# **Lime Down**

Solar Park

## **Change Application and Consultation Report (Change Application)**

**Document Reference: EXAM/9.40**

# Change Application - Change 1

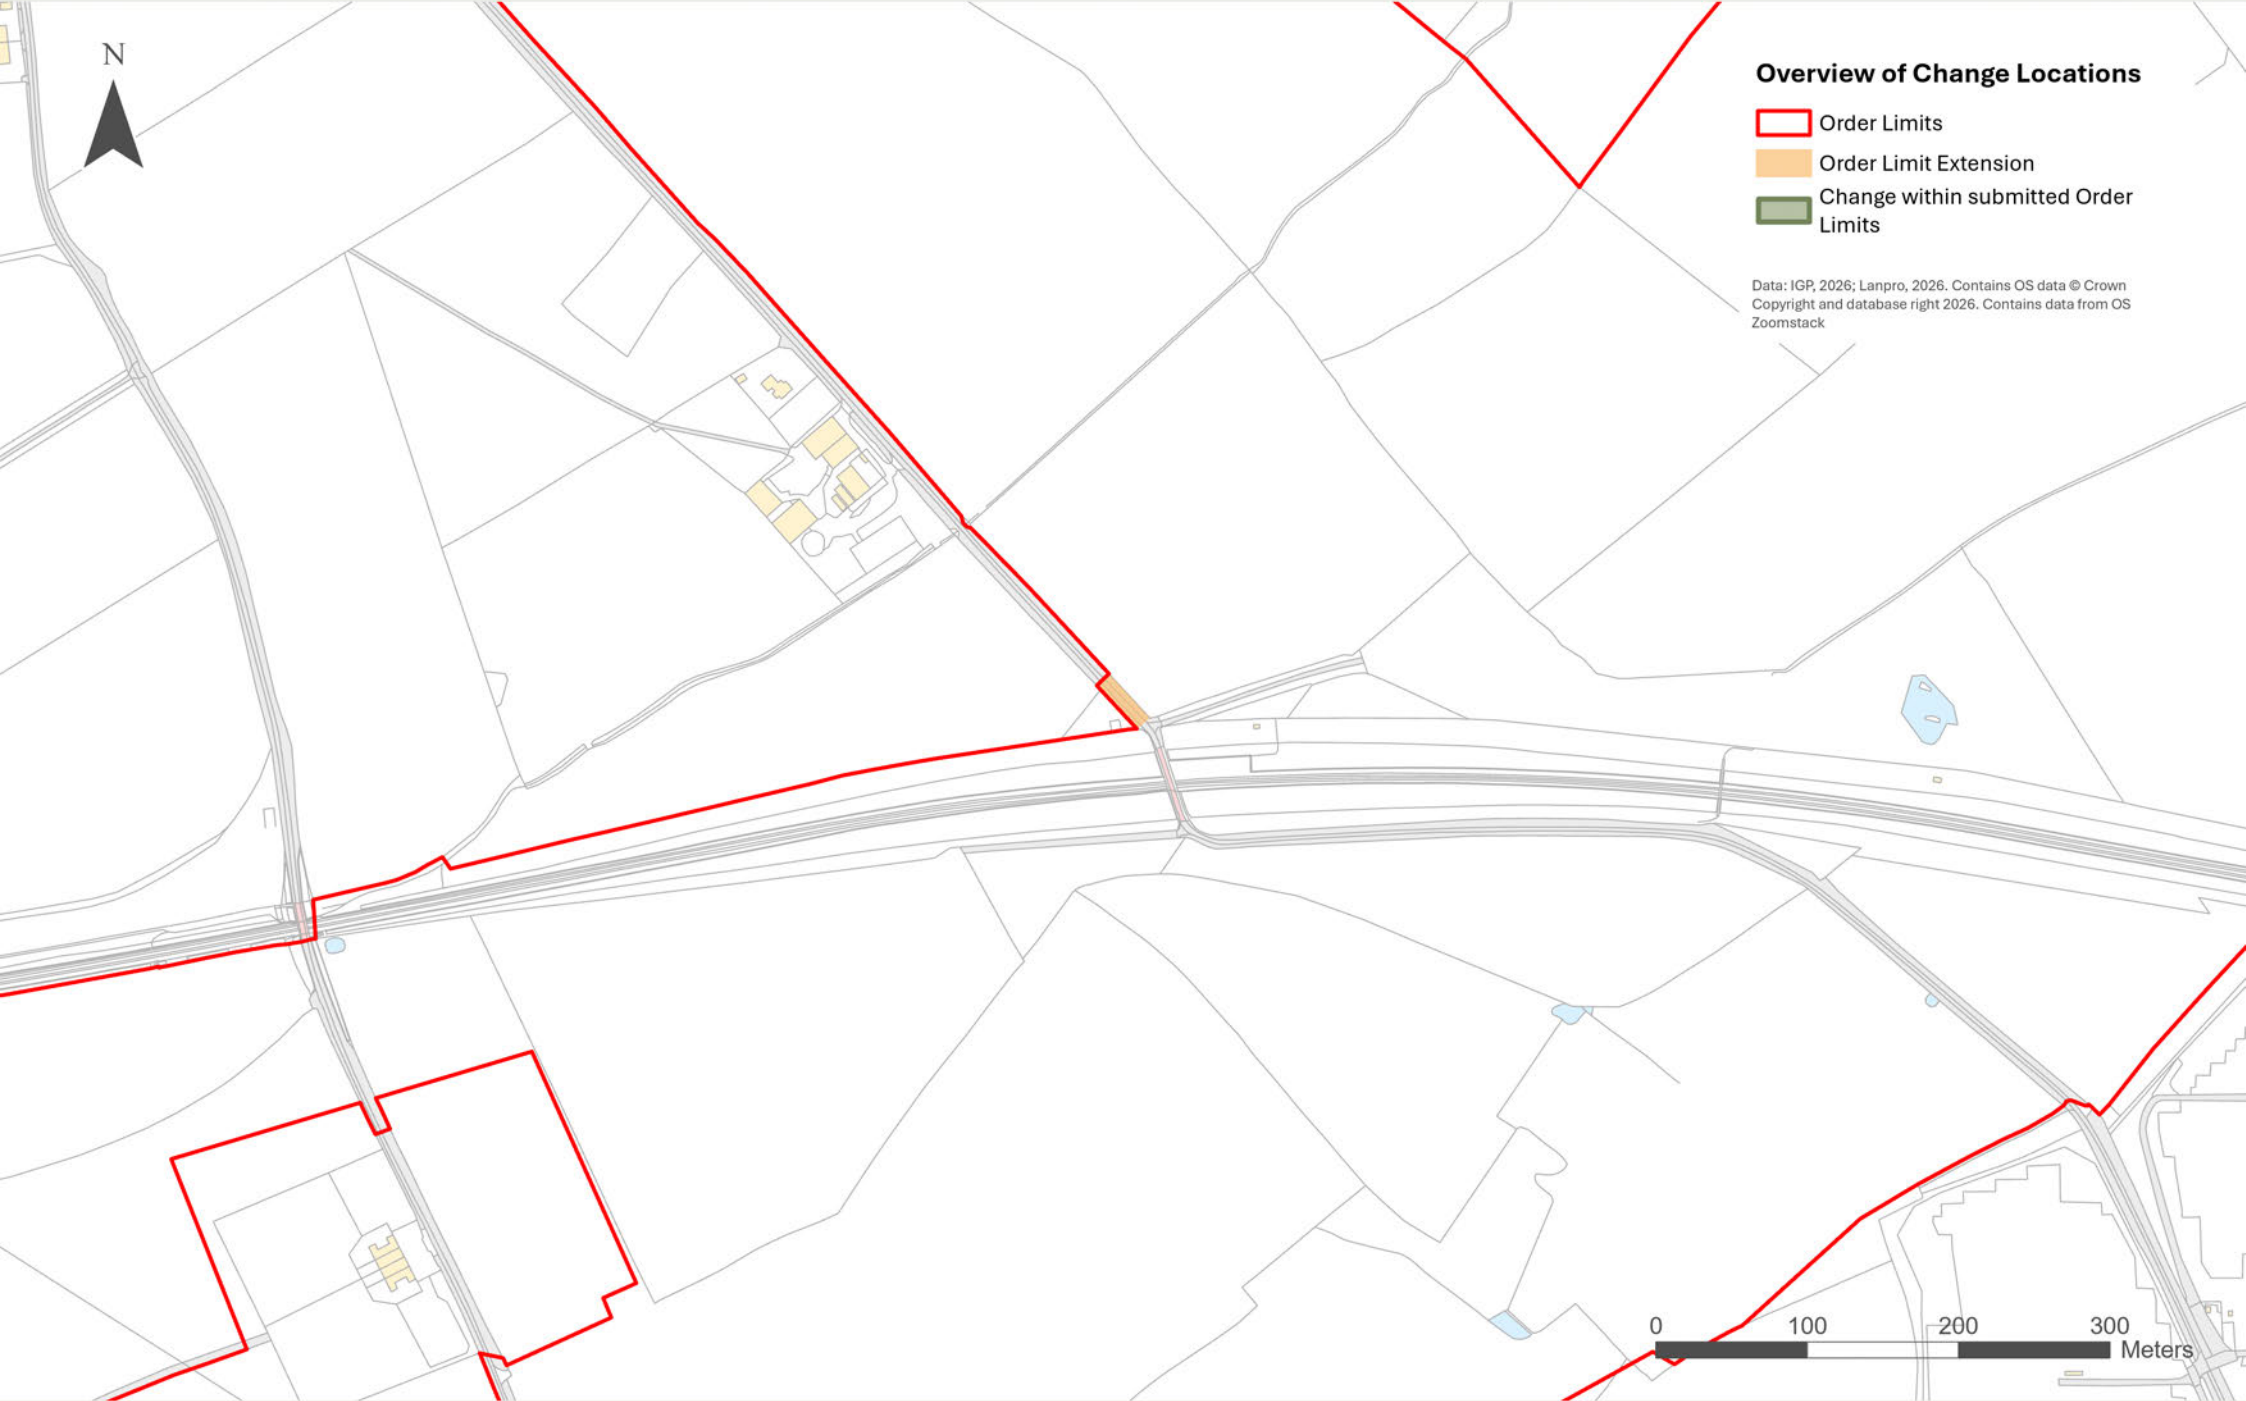
3.1.3 Change 1 comprises an extension to the Order Limits from the south western extent of the BESS emergency access (Access 21, as set out in Table 2 of the **Outline Construction Traffic Management Plan (CTMP) [REP3-108]**) at Lime Down D to the public highway named Hills Hayes Lane. A post-submission review by the Applicant of the Scheme accesses indicated that Access 21 did not adjoin the boundary of the public highway. This change will allow emergency Access 21 to tie into the public highway. The additional land will contain the bellmouth of emergency Access 21 which will comprise hardcore or gravel over a levelling layer of substrate. The additional land will be subject to Work Number 8b.

3.1.4 The area of the land to be added to the Order Limits is approximately 0.044ha. Given the small area of land proposed to be included within the Order Limits, the Applicant considers that the same reasons already provided for within the **Statement of Reasons [EN010168/APP/4.1] [Change Application]** apply to the land added to the Order Limited. Accordingly, there are no changes to the Statement of Reasons proposed as a result of the Change Application, and the reasons already set out in the Statement of Reasons are relied on to justify the modest increase to the Order Limits.

3.1.5 This land will be subject to compulsory acquisition of the rights, and is shown in blue on Sheet 4 of the **Land Plan [EN010168/APP/2.2] [Change Application]** forming Plot 04-036 which has increased in size from 83 to 525 square meters. This comprises land that forms part of the public highway where temporary possession powers are required. This ensures that any works to create the bellmouth junction can be carried out. The **Works Plan [EN010168/APP/2.3] [Change Application]** have also been updated to reflect Change 1.

# Change Application - Change 2

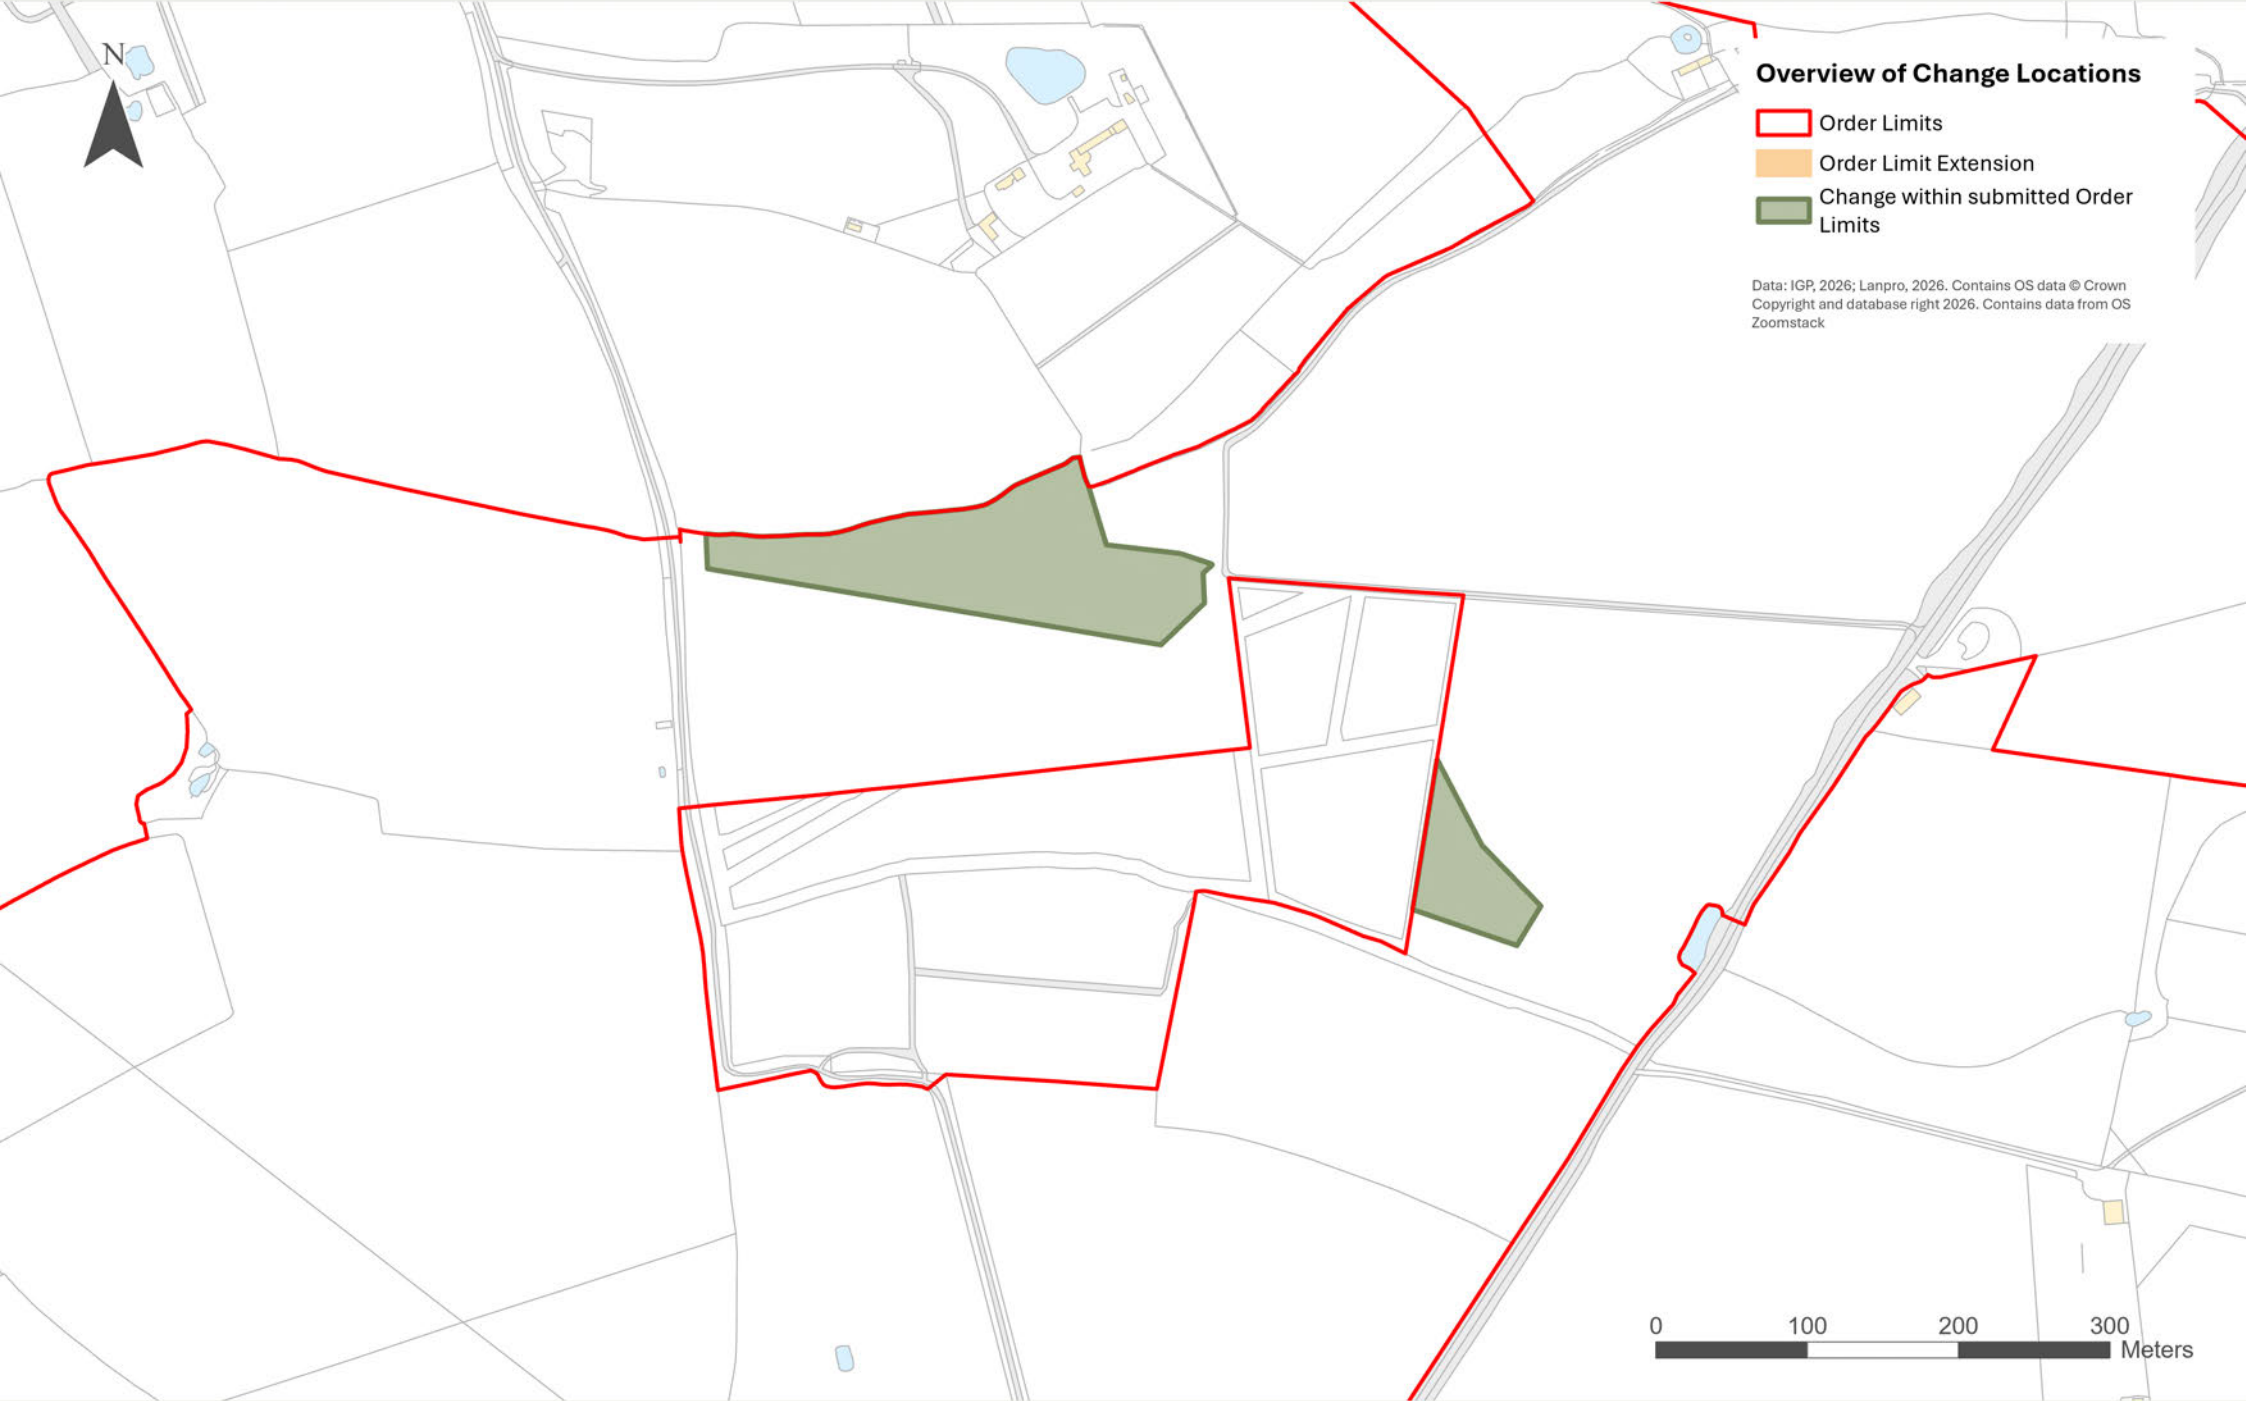
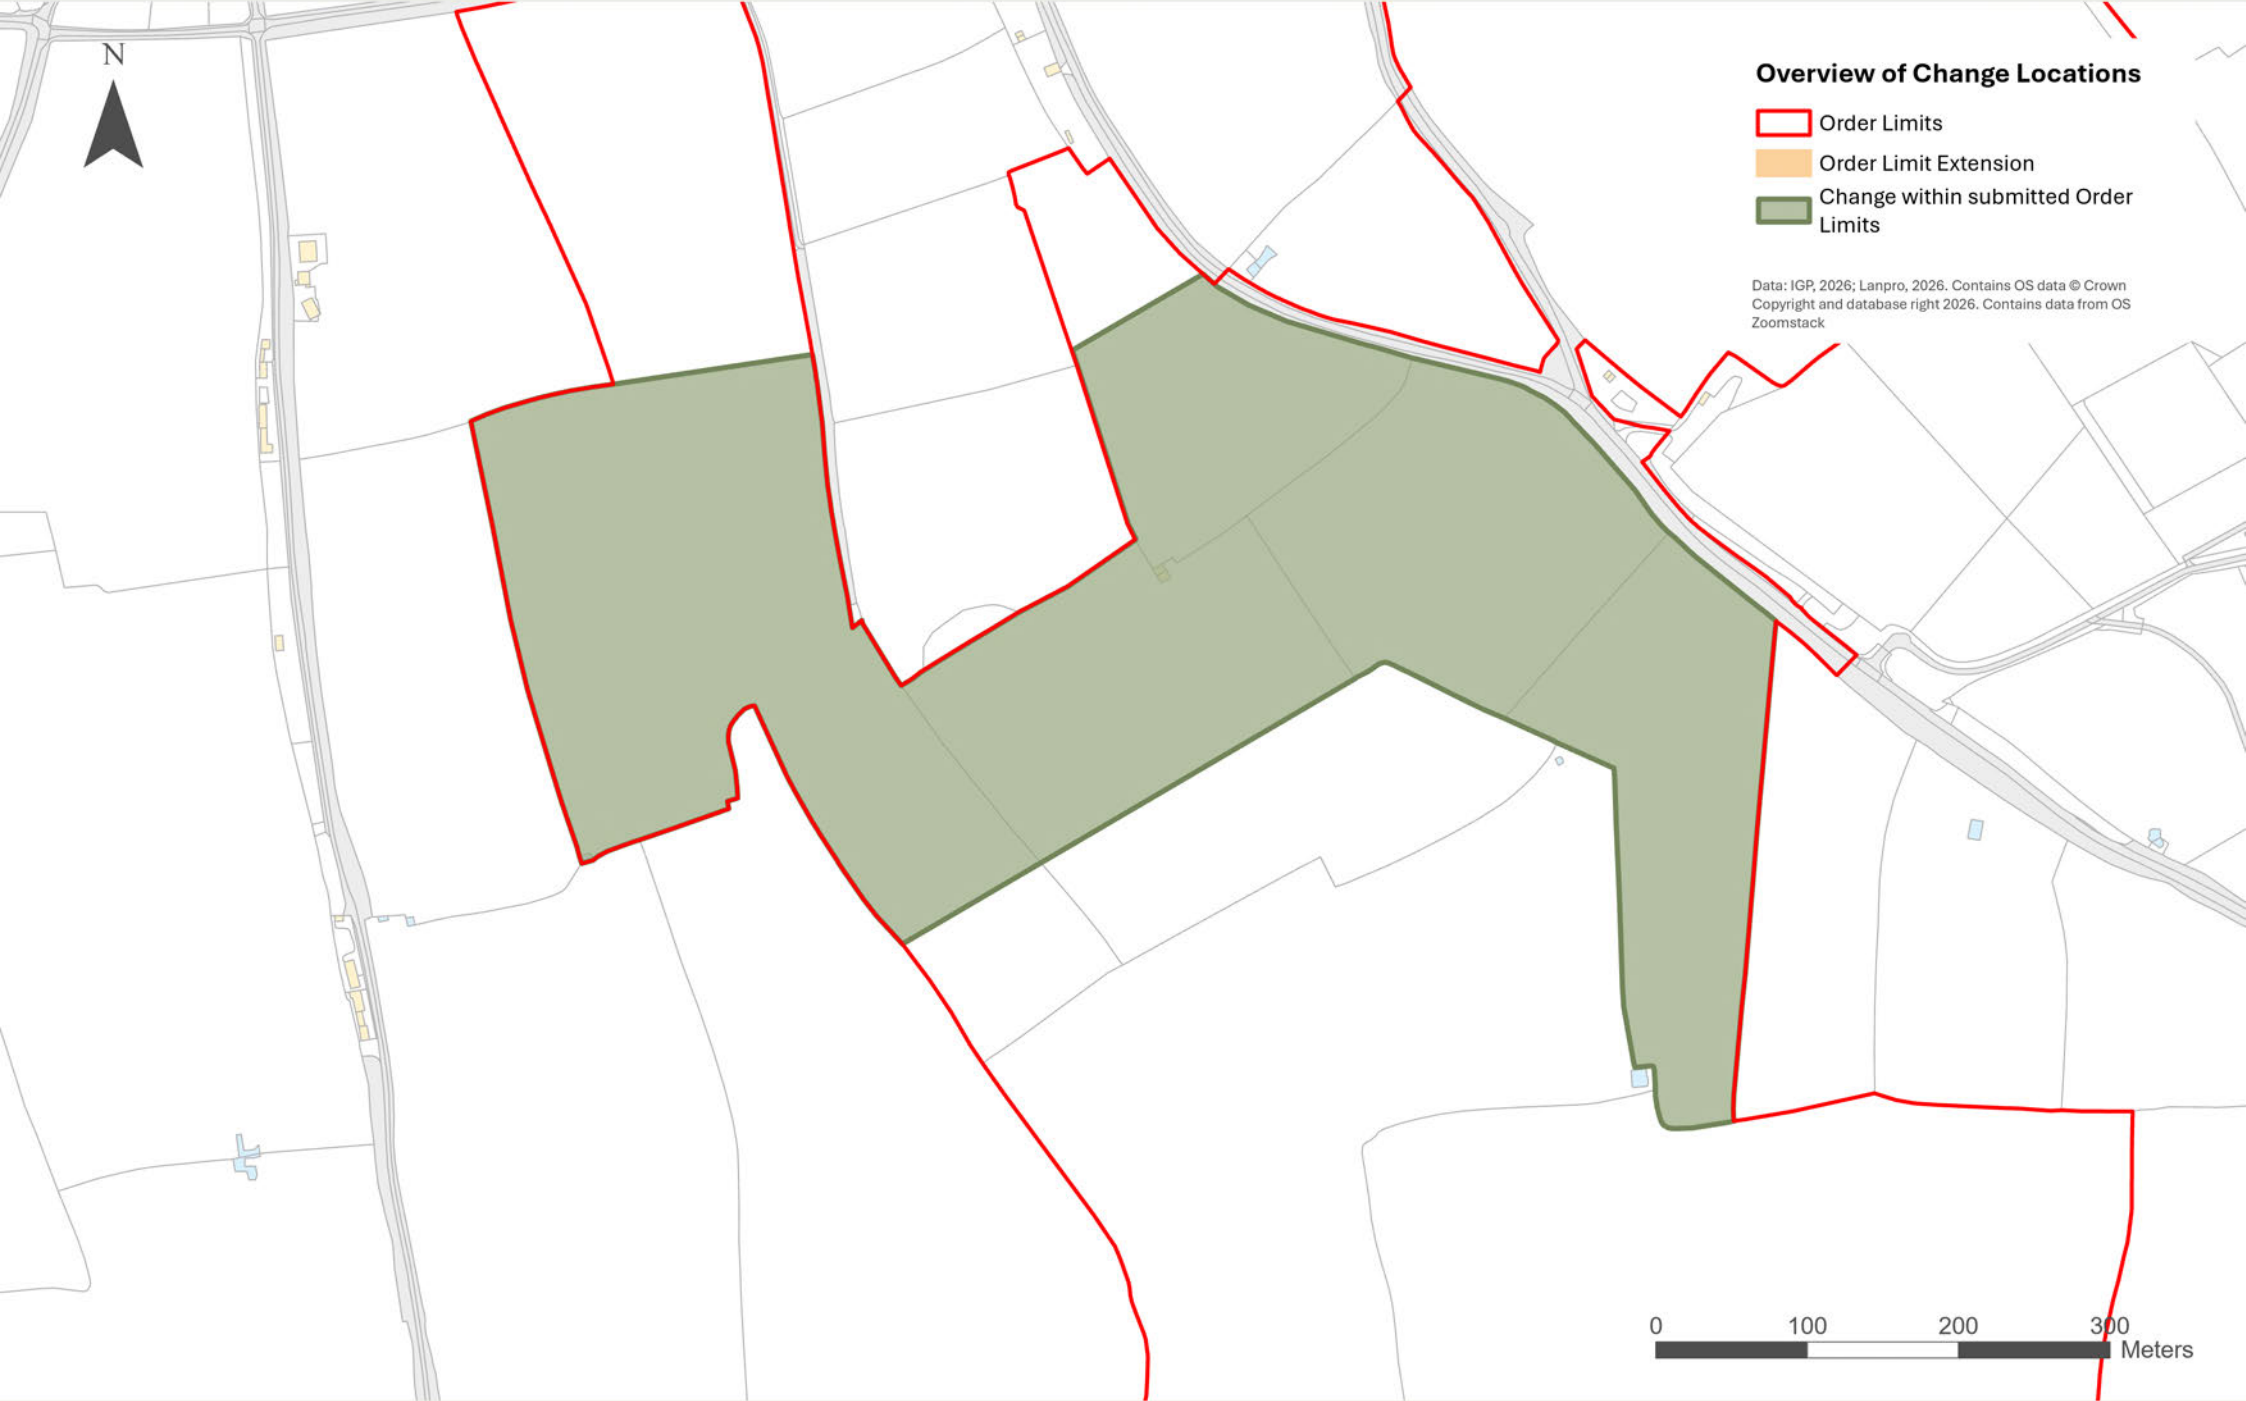
- 3.1.7 Change 2 comprises an update to the Works Plan to reflect the realignment of Solar PV Infrastructure within parts of Fields C21 and C23. This change reflects updated GIS data provided by Wiltshire Council that confirms the alignment of PRoW WT/SHER/18 as per the definitive map dated 5 March 2026, which has changed since the DCO Application was submitted.
- 3.1.8 There will be no change to the extent of Work Number 1, and the realigned Solar PV Infrastructure will retain a 15m offset from the PRoW.
- 3.1.9 The **Works Plan [EN010168/APP/2.3] [Change Application]** and **ES Volume 2, Figure 3-4 Landscape and Ecology Mitigation Plan [EN010168/APP/6.2] [Change Application]** have been updated to reflect Change 2.
